**RE: Solar Photovoltaic Plants
2150 Dryden Road
Dryden-Tompkins Solar II, LLC
Response to Revised Interconnection Review by T.G. Miller, P.C.**

**RE: Solar Photovoltaic Plants
2150 Dryden Road
Dryden-Tompkins Solar II, LLC
SWPPP Modification Report**

FIGURE 1

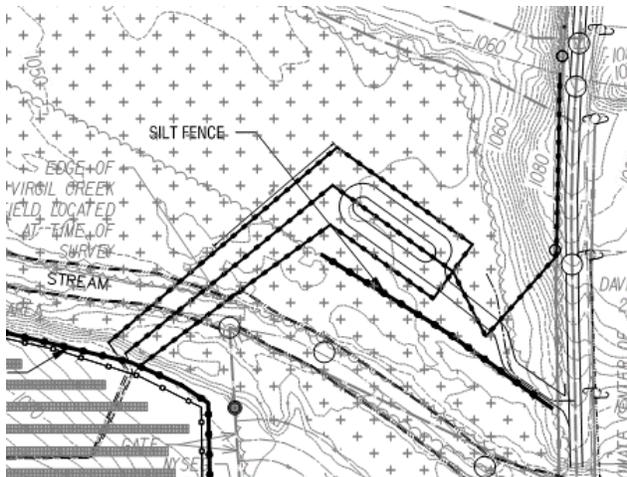
The Sediment and erosion control plan shows silt fence between the access road and the stream. (see figure 1) and the existing meadow vegetation will be maintained between the pole line and the wooded streambank.
